Immingham Eastern Ro-Ro Terminal

Deadline 9 Submissions

**Associated Petroleum Terminals (Immingham) Limited and
Humber Oil Terminals Trustee Limited**

**Specific Responses to Deadline 8 Submissions by the IOT
Operators**

Run 11

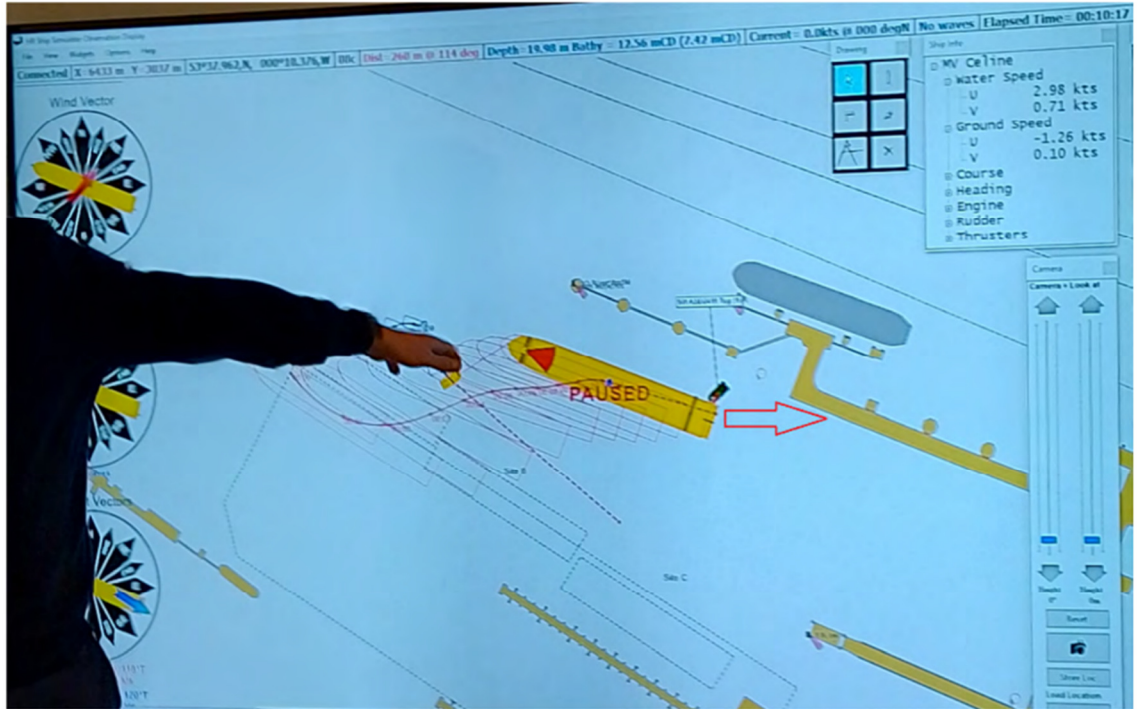
8.2 The below image is taken from the December Simulations included in the Appendices to the IOT Operators' Deadline 8 Submissions [REP8-057] which demonstrates the essence of the IOT Operators' concerns.

Summary of the key design parameters as provided by ABP

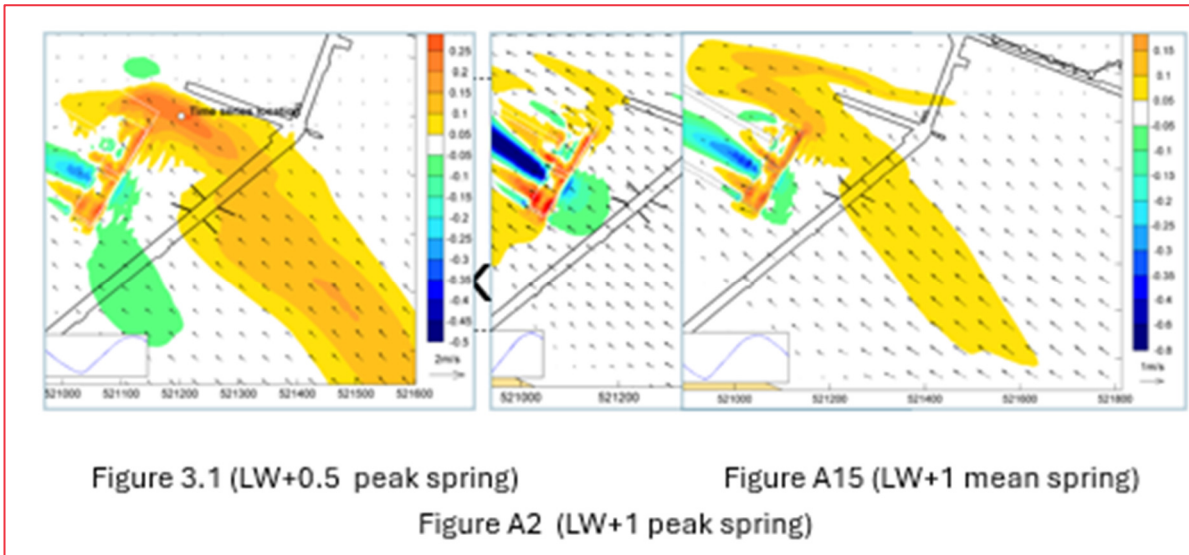
1.6 However, the model does not include any effects on flow for the new structures except that of the floating pontoons themselves. While the pontoons will have a major effect on flows, the effect of the piles to support/restrain the pontoons, the new finger piers and the impact protection piles are not considered within the flow model. This is despite the pile spacing / pile diameter ratio for these structures being close to or less than the 10:1 ratio noted in the report as causing significantly enhanced effect on the passing flow, as evidenced in the summary of the key design parameters in the box below.

1.7 Omitting a representation of these structures from the flow model will lead to an under-representation of the changes to flow conditions brought about by the proposed scheme and thus the impact on navigation in the area. By ignoring these structures in the flow model, the flows used within the navigation simulations are likely to be different to those experienced in the prototype if/when built.

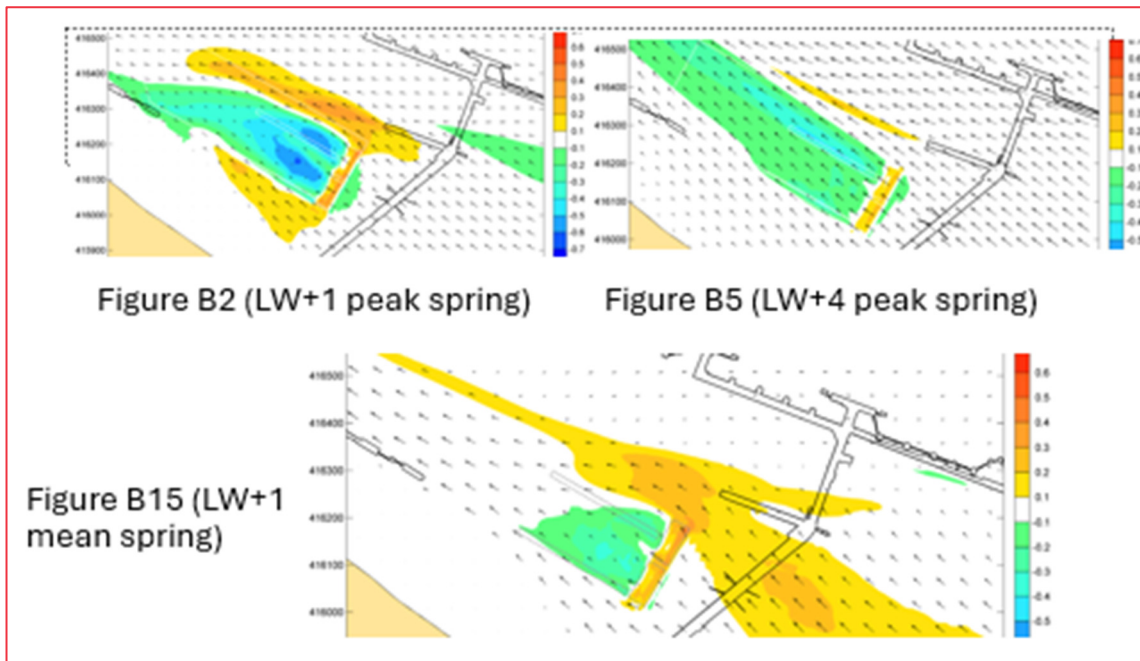
1.15 The plots in Appendix B do show significant changes in current speed, including increased current between the pontoons and the IOT finger jetty as illustrated below. The current vectors in these plots appear to show the revised current directions and speeds, but there are no baseline vectors to show the change in direction.

1.16 The reporting presented paints a somewhat rosy picture of the impacts brought about by the IERRT pontoons on flows that will occur - these will materially increase the difficulty of berthing vessels on the IOT Finger pier, particularly on berths 8 and 9 (south side berths).

1.17 Section 3.3: Flow conditions between IERRT and IOT

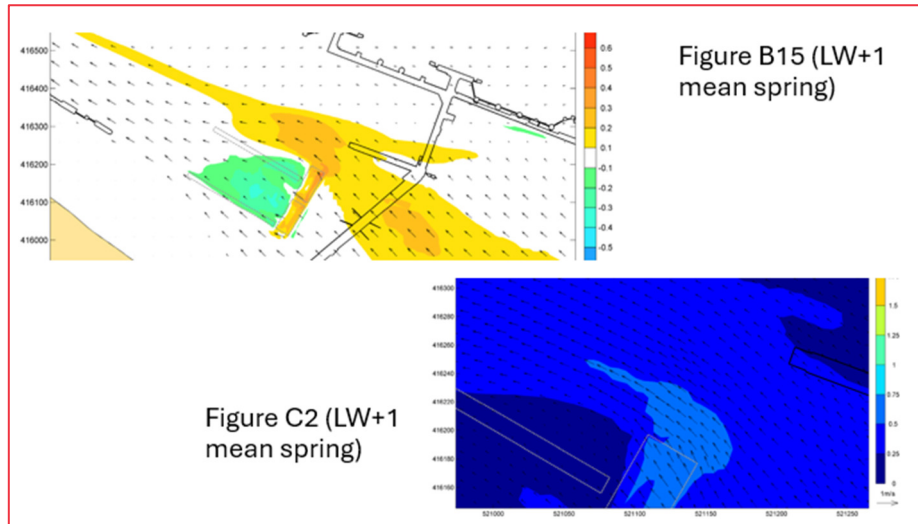
- 1.18 The text states that “*These results confirm that whilst some deflection of the currents around the pontoon does occur, no large scale eddies which might influence vessels are seen.*” In discussion with HR Wallingford regarding the modelling, they confirmed that the Telemac model used for this work would not simulate the smaller scale eddies/eddy shedding from the pontoons and piles of the IERRT and this would typically require computational fluid dynamics or physical modelling to assess. Their contention is that the scale of such eddies, if not seen in the Telemac model, would be too small to influence vessel manoeuvring. This does not seem an unreasonable view but it is noted that there may be larger scale eddies present in peak spring tides, for which no figures have been provided.

- 1.19 The plots in Appendix C are only presented for mean spring tide conditions, and as such would occur for 50% of the time. The scale and likelihood of larger scale eddies is expected to be greater for peak spring tides when the peak velocities will be higher and the changes in water elevation and water depth will be greater. It is difficult to rely on the results of these results without analysis and plots for peak spring tides should be provided.

- 1.20 Furthermore, the differences in current speed which the figures shown in the Appendix C plots purport to present are much lower than those shown in Appendix B for apparently the same tidal events and times (even noting the difference in use of contour band colours). As shown below, the maximum difference in speed at the northern tip of the pontoon for a mean spring tide at LW+1 is shown as 0.3-0.4m/s (0.6-0.8kn) in Figure B15, but 0.5-0.75 m/s (1-1.5kn) in Figure C2. The figures in Appendix C are unclear as to whether they show actual current speeds not a difference in current speeds.
